# Council Business Meeting

<b>Agenda Item</b>	Community Center and Pioneer Hall Ad-Hoc Committee Recommendations	
<b>From</b>	Scott Fleury PE Kaylea Kathol Rachel Dials George Kramer	Public Works Director Senior Project Manager Recreation Superintendent Historic Preservationist
<b>Contact</b>	<a href="mailto:Scott.fleury@ashland.or.us">Scott.fleury@ashland.or.us</a> <a href="mailto:Kaylea.kathol@ashland.or.us">Kaylea.kathol@ashland.or.us</a> <a href="mailto:Rachel.dials@ashland.or.us">Rachel.dials@ashland.or.us</a>	541-552-2412 541-552-2419 541-552-2260

# **Winburn Way Ad Hoc Committee**

**REPORT TO THE ASHLAND CITY COUNCIL**  
**21-September-2021**

Figure 1. Winburn Way Community Center, Main Space, Proscenium Arch

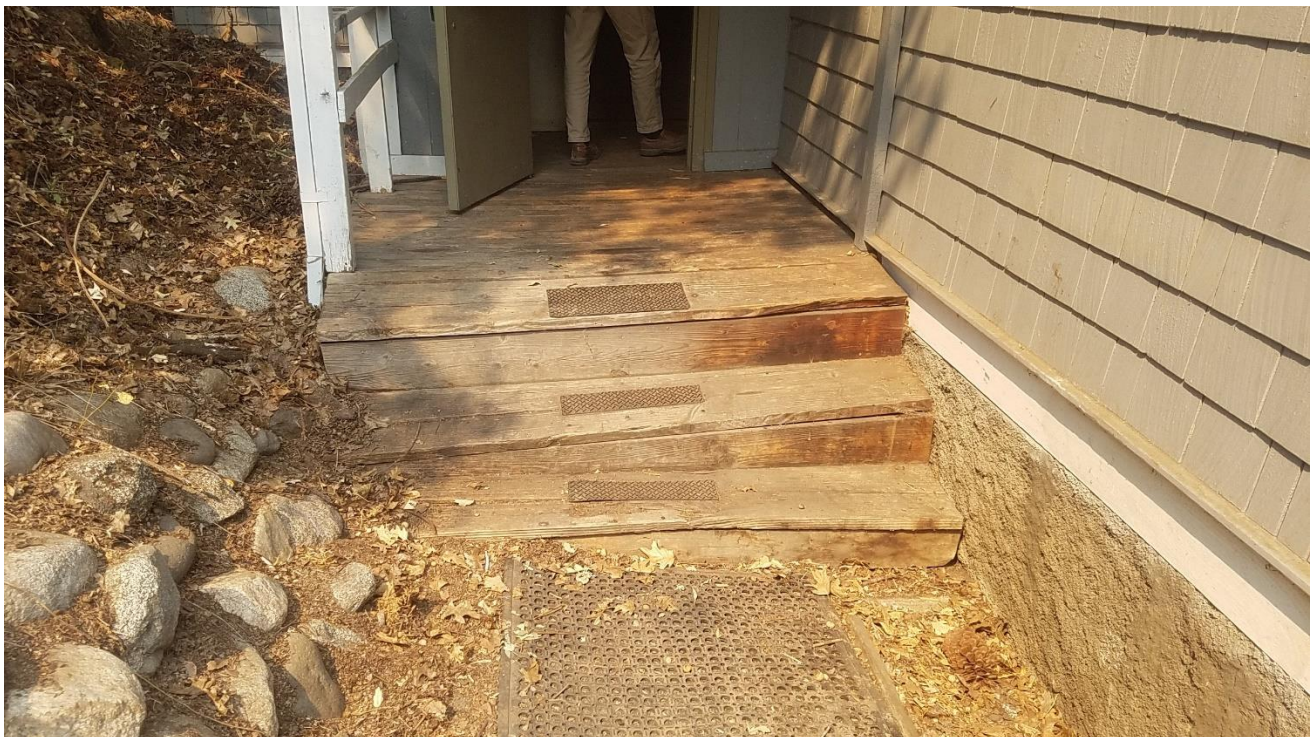
The roof is idiosyncratically framed and subject to multiple recommendations for improvement as per Eric Snyder, P.E. and detailed in his memo, attached. The primary solution involves the construction of a steel moment frame to span the main auditorium and create additional support for the existing timber trusses. This will involve installing a series of columns along the perimeter of the auditorium, with steel beams below the truss and phantom bearing wall at the rear (west) end of that space, with new footings at grade, through the existing wood floor. Installation of the moment frame will be mitigated by painting all elements white, to blend into the ceiling, and applied trim to match existing treatments. All verticals here will be plumb, meaning that some form of tapered blocking will be needed between the columns and the north wall for aesthetics. Careful evaluation of the westernmost beam run to minimize impact to the proscenium is recommended (see Figure 1).

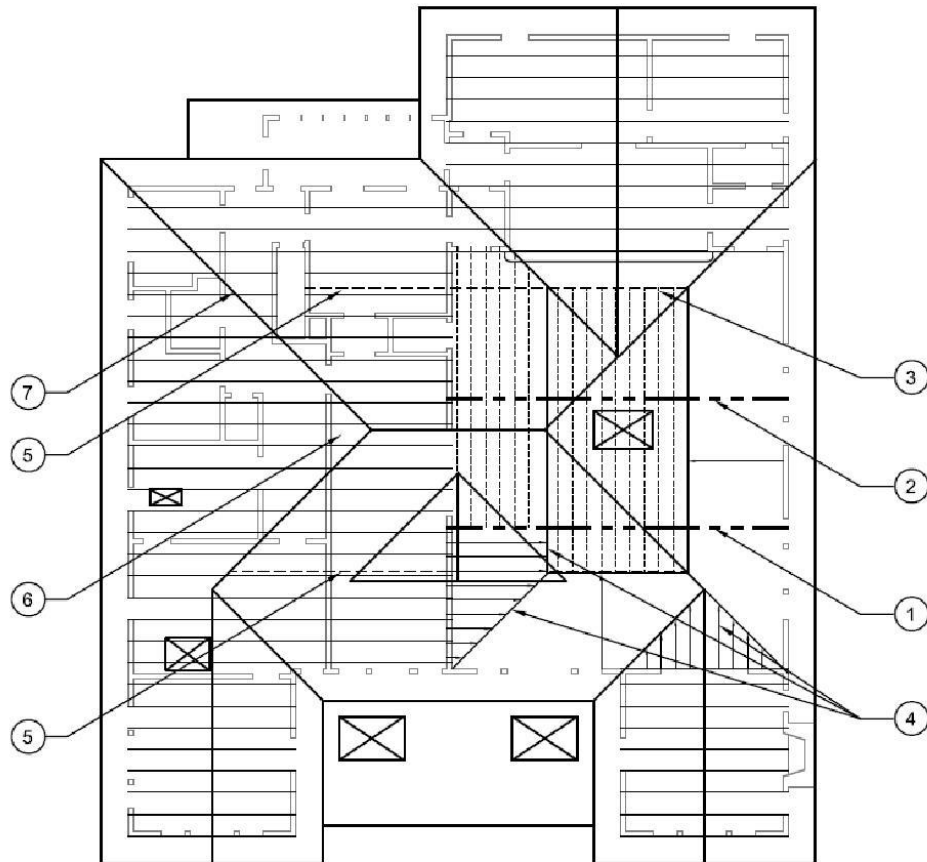
1. The North Wall and foundation wall are out of plumb, a situation that likely existed and may have in part motivated the 1985 repairs.
2. Portions of the roof over the "Main Hall" are sagging, potentially as much as 15 inches.
3. Portions of the ceiling over the "Main Hall" are sagging on the interior, particularly the west end of the hall, adjacent to the stage.
4. Roof Framing members are over-spanned, and / or improperly supported.
5. Exterior diagonal wall sheathing that fastened to the foundation was previously cut off above the foundation walls, and does not provide lateral shear-force transfer from the building to the foundation.
6. There are gaps between support posts and footings below the main floor framing, resulting in over-spanned floor framing members.

Please refer to this sketch showing the approximate As-Built ceiling framing of the Ashland Community Center.  
Keynote comments are listed on page 4.

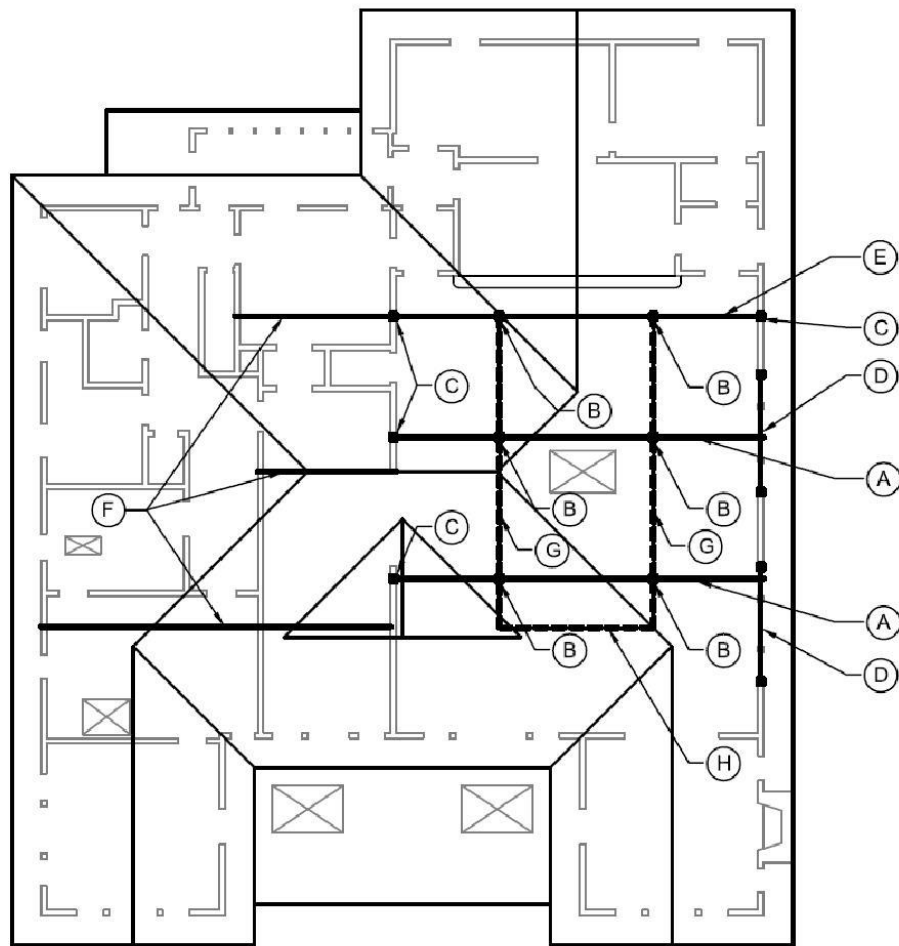
There is a phantom bearing wall in the vaulted ceiling of the Main Hall, a couple of feet back from the stage. This phantom bearing occurs where ceiling joists have insufficient length to extend to the intended support beam, spanning over the stage, because of a spacial conflict with the roof framing. In addition to the ceiling joists, some rafters on the south end of the Main Hall are also “supported” along this phantom bearing line. This condition is causing the ceiling to sag below, and is potentially dangerous.

Similar to my previous recommendation, there is a lack of sufficient space in the ceiling and roof cavity to address this structural deficiency above the ceiling. Therefore, I'm recommending another beam to be located below this phantom bearing line (E) in the Main Hall below. This beam should be supported by

new steel columns in the north and south walls (C), and have a pony wall constructed above to meet the ceiling, and support the insufficiently-supported roof and ceiling framing above. Effort should be made to lift the sagging ceiling with jacks, before constructing the pony wall. As with the above recommendation, support (C) will be placed to the interior of the north wall, and extend through the existing floor to a new pier pad below. To avoid obstructing the stage, the cross beam Gil Livni and I have discussed options to either arch the cross beam, or to otherwise step it up higher toward the interior of the room.

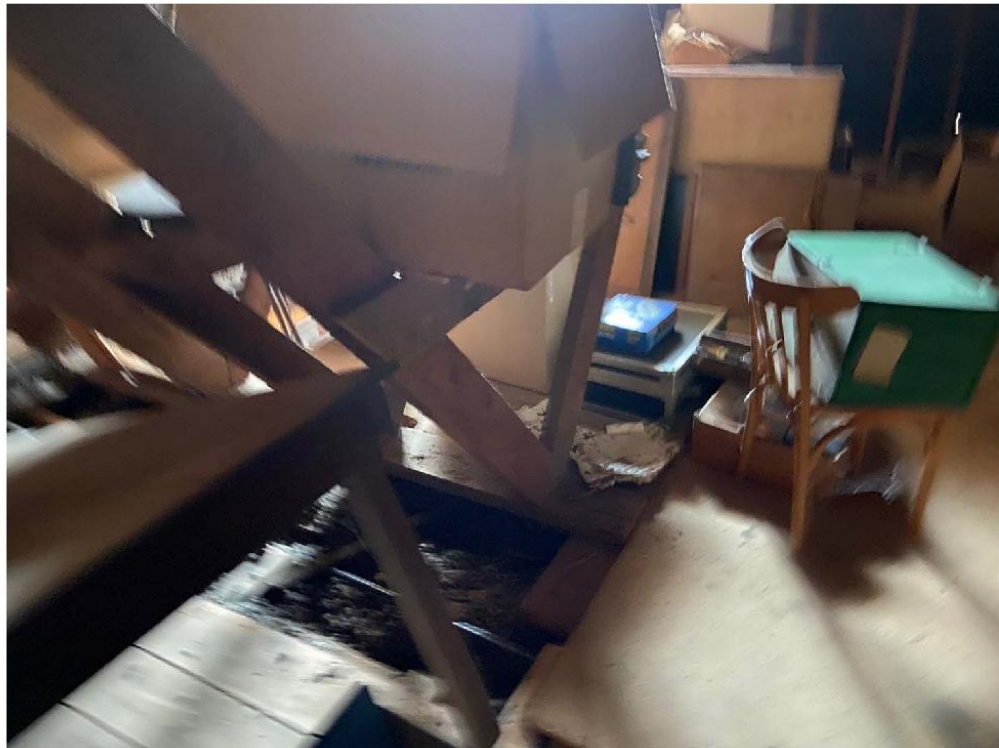
Several of the sloped ceiling joists over the Main Hall appear to rely on existing 2x4 rafters for their top support. This occurs at the south-east end of the Main Hall, just to the east of Truss (1), where ceiling joists run up the vaulted ceiling slope, and somehow tie into rafters. Based on my initial analysis, it appears that a similar condition is likely occurring (although is not visible) where the northeast dormer intersects the ceiling of the Main Hall. The load path of this framing, from ceiling joist, into rafters, into hip/valley, to wall, should be simplified as much as possible, as the valleys and rafters are already over-spanned.

For general added roof support in this area, I'm recommending adding some new wooden beams (G) to span between the trusses. These beams can be used to support the over-spanned rafters on the north side of the Main Hall. I would have them extend to the east, cantilevering over Truss (1) to support a perpendicular beam (H) to support rafters.

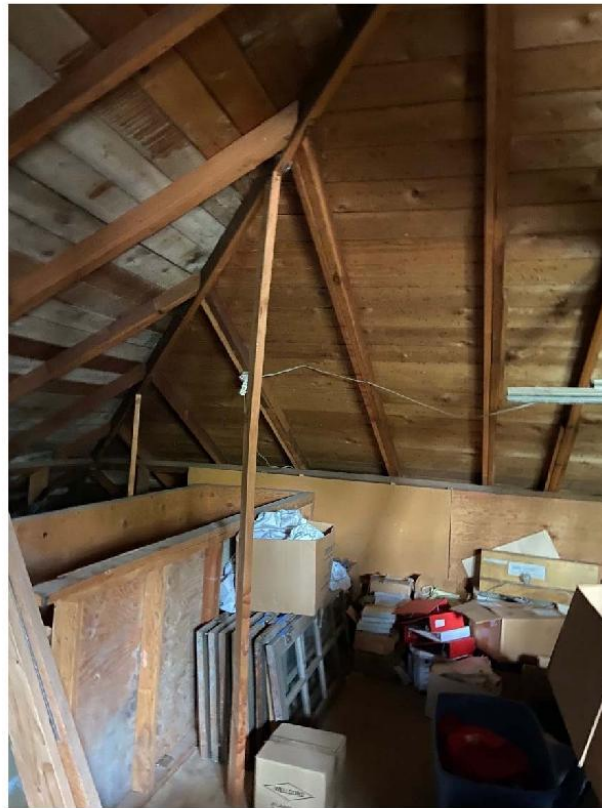
Between my site observations and CAD sketch, it is unclear that existing pony walls (5) or diagonal braces (6), that have been constructed in the attic space to support the rafters have a load path below the ceiling. They appear to span across open rooms, with no clear load transfer to the foundation below that.

It may be necessary to add a support beam (F) along the side of these pony walls. This can be done in the attic space, above the ceiling, and will likely consist of 2x12 members spanning between walls below. Further investigation is required to determine the exact recommendation.

Figure 12. Proposed Retaining Wall, to be constructed at rear of both Winburn Way CC and Pioneer Log Cabin (Section), Snyder Engineering, 2021

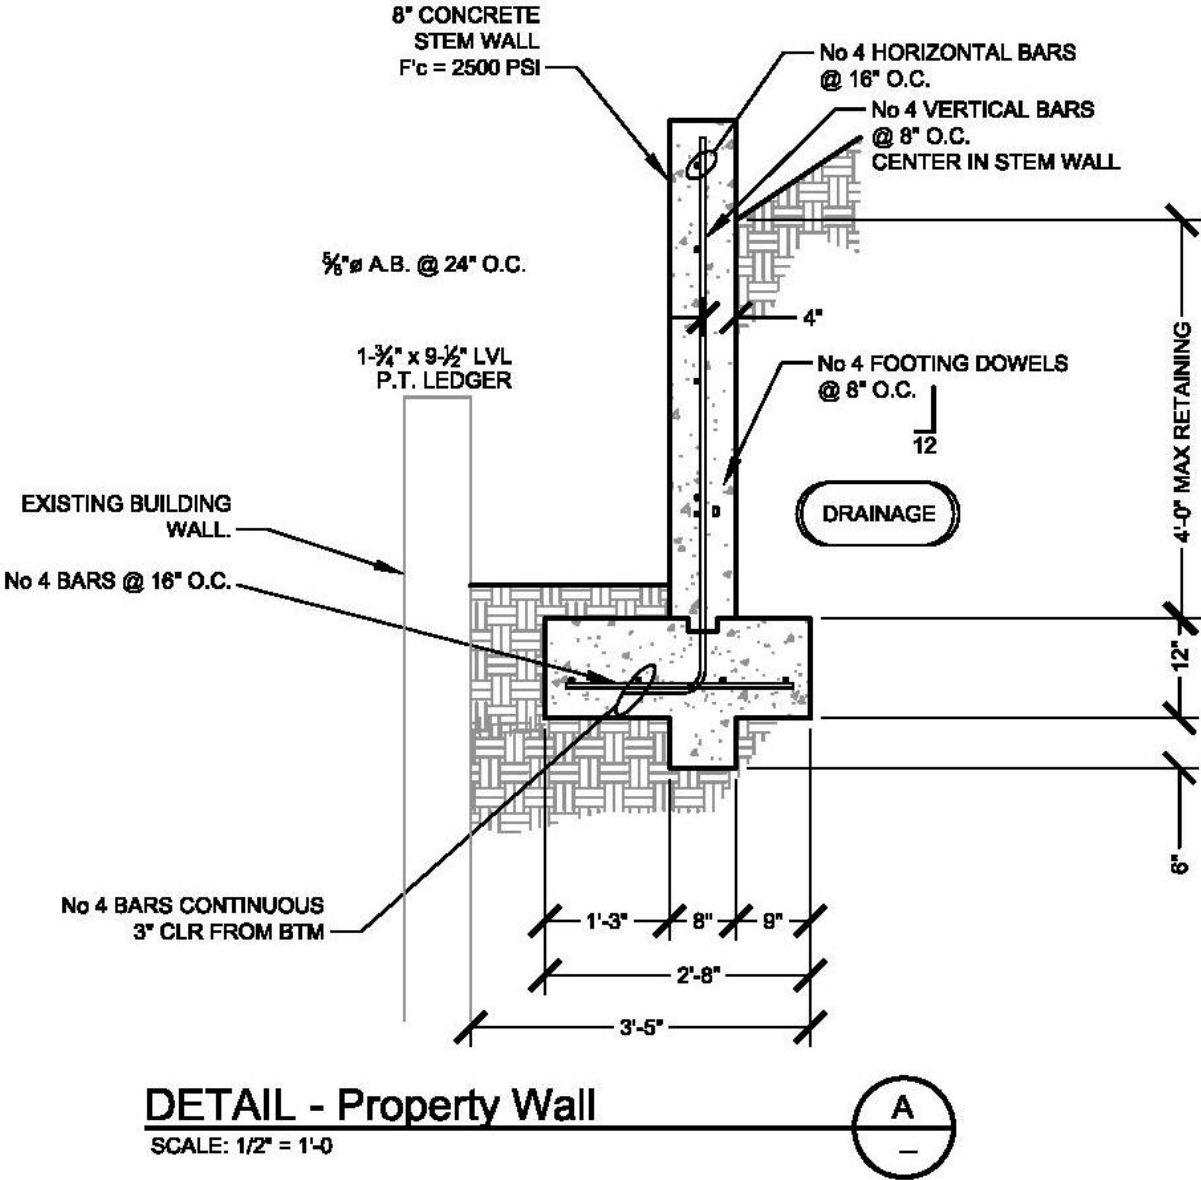
- E. Retaining Wall & Fire Break: The sloped site at the rear of both buildings creates a sloughing issue that leads to large debris piles of dirt and leaves (see Figure 4). Staff reports that this area is also prone to unauthorized access, creating a hazardous situation that complicates debris removal and maintenance. The banked debris against the wood foundations of both the Community Center and Log Cabin increase decay by trapping moisture, provide an access point for vermin, and, most importantly, represent a significant fire danger. All of these issues are further exacerbated by unauthorized access. The Ad Hoc Committee strongly recommends that the slope be excavated, and an engineered concrete retaining wall be installed approximately three feet (36") away from the foundation, with a new concrete slab/walkway to provide separation (see Figure 12). The slab will be designed with drainage to reduce water into the basement/foundation and should extend at the northwest corner to correct and improve access to the WWCC basement.
